June 2, 1993

The purpose of this letter is to thank you for your cooperation with the NRC staff on issues regarding digital instrumentation and control system upgrades, and to transmit the NRC staff comments on the draft "Guideline for Licensing Digital I&C Upgrades." The enclosed comments are in the form of strikeouts and redline of the original draft. The primary NRC staff concern, as discussed in our meeting on the 15th of April and as reflected in our comments, is the need to clearly establish a threshold for NRC staff review of certain digital I&C system upgrades, primarily based on the impact of software reliability and electromagnetic environment on the current plant safety analysis.

Document Name: NRC-UPDT.LTR

Figure 2  
Addressing Software  
Common Mode Failure

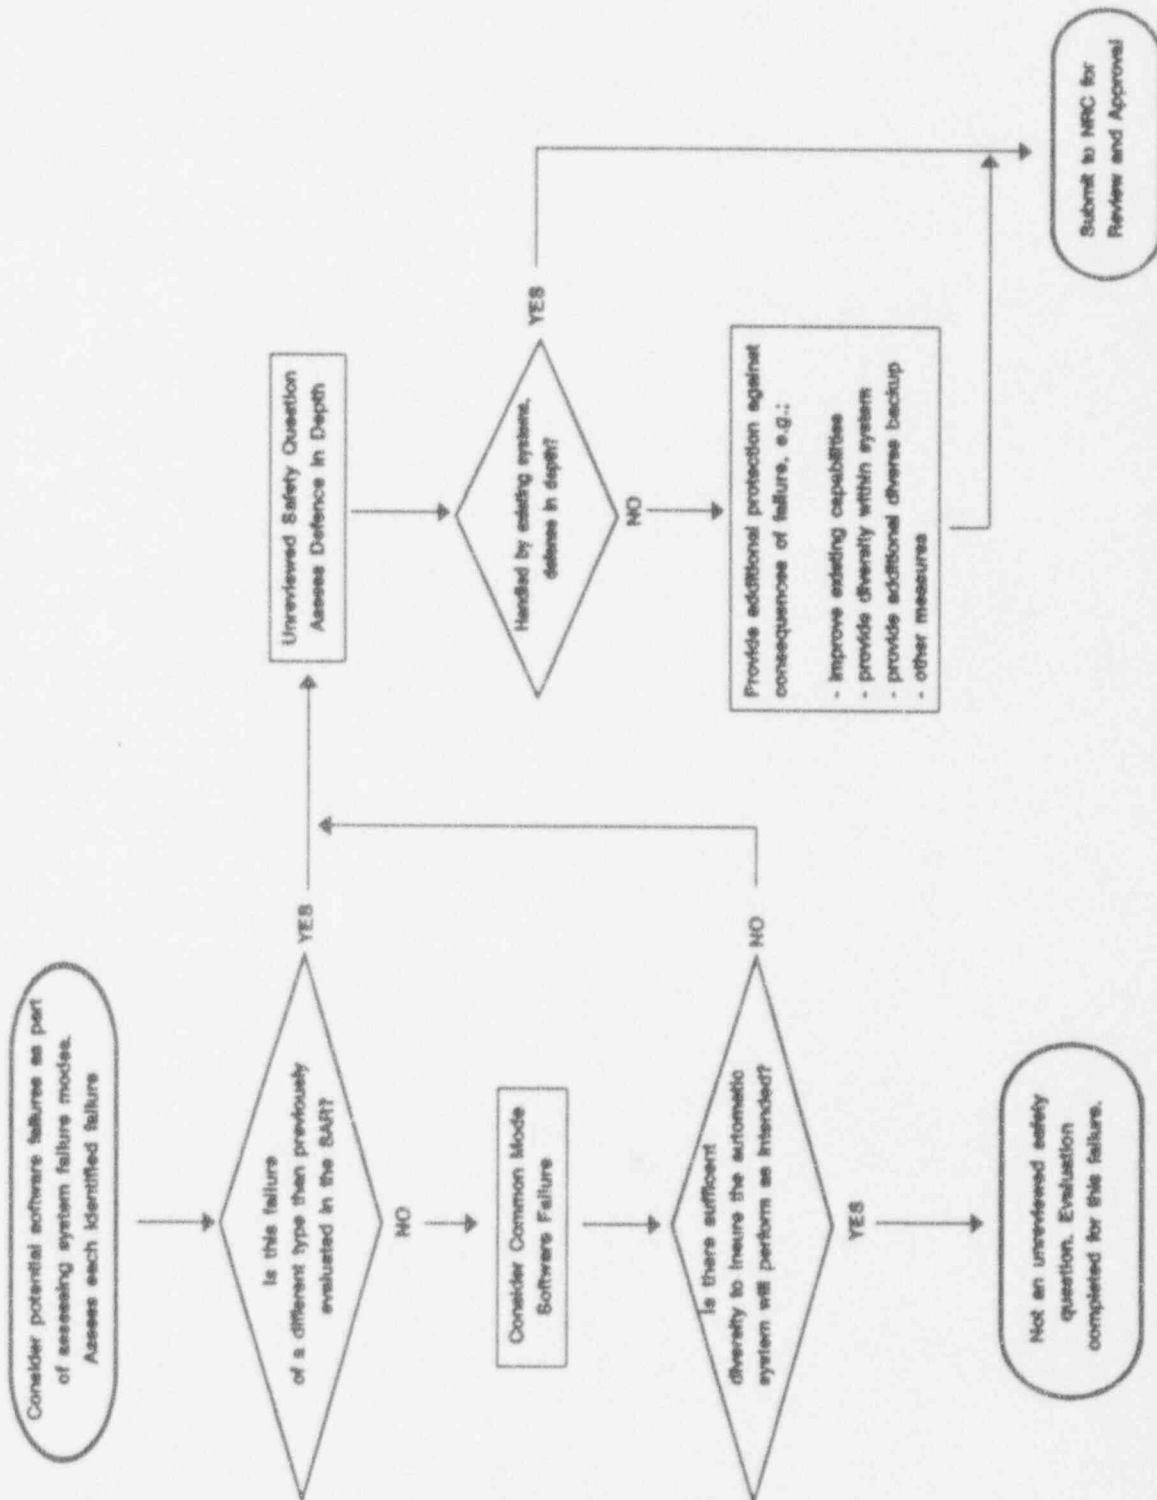
1. ~~Assess whether the~~ Since it is considered impossible to prove that software is error free, software failure is deemed to be credible:
  - For simple systems which have extensive experience (both hardware and software), the measures taken to ensure software quality combined with successful operating experience gained with the system may be such that a software common mode failure

~~is not considered credible, less likely, but is still credible. Note that, for protection systems, the portion of the software that is critical to the system performing its safety functions is actually very simple because the functions it performs are simple (comparison of a signal to a setpoint, simple signal conditioning, etc.).~~

- For more complex systems or systems that have not seen extensive operating experience, software common mode failure may be ~~considered credible~~ more probable and, if so, should be given further evaluation (below).

2. ~~Assess the probability of the software failure, combined with probabilities of other events that also must occur (if any) for the consequences of the failure to be significant. For example, if the system under review is a backup system that must perform only when certain events occur, then a software failure in that system is important only if it could occur coincident with these other events producing the need for the backup system. It is important to assess the combined probabilities to place the failure in the appropriate context and determine whether it is meaningful.~~

~~If the probabilities are significant and warrant further consideration, then the consequences of the failure should be assessed (below).~~

3. ~~Assess the consequences of the software failure, assuming it does occur. Determine whether the consequences of the software failure represent new type of system level failure that has not previously been considered, an accident or malfunction of a different type than evaluated previously. It should be remembered that there is no guidance for quantitatively assessing software failure probabilities at this time. If the system under review is a backup system that must perform only when certain events occur, then a software failure in that system is important only if it could occur coincident with these other events producing the need for the backup system.~~

~~If the consequences of the failure are not new and already have been addressed a software failure of this type has already been evaluated and documented in the safety analysis report, then this particular failure need not be considered further. It would not represent an unreviewed safety question per 10CFR50.59.~~

However, if it is concluded that this is a new type of ~~system level~~ failure, then protection against the consequences of the failure ~~should~~ shall be considered (below). Note that this typically would mean the change involves an unreviewed safety question per 10CFR50.59 and NRC review and approval would be required prior to implementation.

43. Assess the defense in depth that is provided which would mitigate the effects of the plant design basis accidents ~~even~~ if the upgraded system suffered the software common mode failure. There are several options for demonstrating adequate defense in depth:
  - Demonstrate that there is defense in depth with existing systems, procedures, and training which is adequate to mitigate the effects of the design basis accidents ~~even~~ if the upgraded system suffers the software common mode failure of concern — this may include taking credit for operator action under defined circumstances, and it may include the use of nonsafety-related equipment, providing in either case, operator
